3000 BRUTON BLVD.

SUMMARY

Owner and El Bethel Temple at Orlando, Inc. Applicant Alex Stringfellow, Stringfellow Planning & Design Project Planner Megan Barrow Updated: June 9, 2022	Property Location: 3000 Bruton Blvd. (PIDs: 29-23-05-2485-00-010) (±2.165 acres, District 6), generally located west of Bruton Blvd., south of Prince Hall Blvd., east of Mary Church St., and north of L.B. McLeod Rd. Applicant's Request: 1. Change the future land use designation from Residential Low Intensity (RES-LOW) to Industrial (INDUST) 2. Rezone from One-Family Residential (R-1) to Industrial Park (IP).	Staff's Recommendation: Approval of the request, subject to the conditions in this report. Public Comment Courtesy notices were mailed to property owners within 300 ft. of the subject property the week of June 6, 2022. As of the published date of this report, staff has not received any comments from the public concerning this request.

Conceptual Site Plan and Elevations

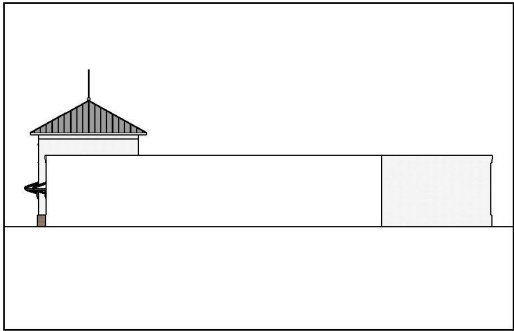
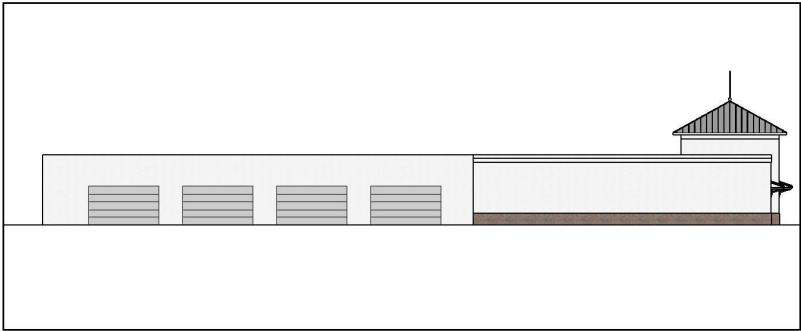
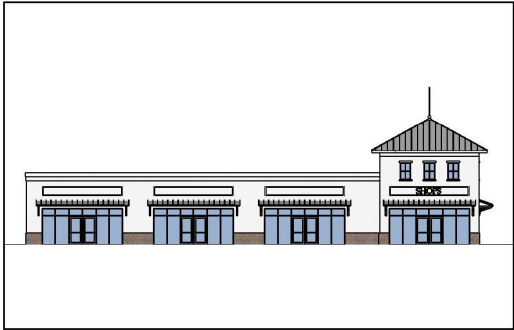
Upon initial review of the concept plan and elevations, staff encourages the proposal of neighborhood-friendly architecture such as non-flat roof shapes, awnings, and landscaping at the building base; staff would also want to see pedestrian-friendly sidewalk access and parking lot landscaping to complement the surrounding R-1 church-and-residence neighborhood character.
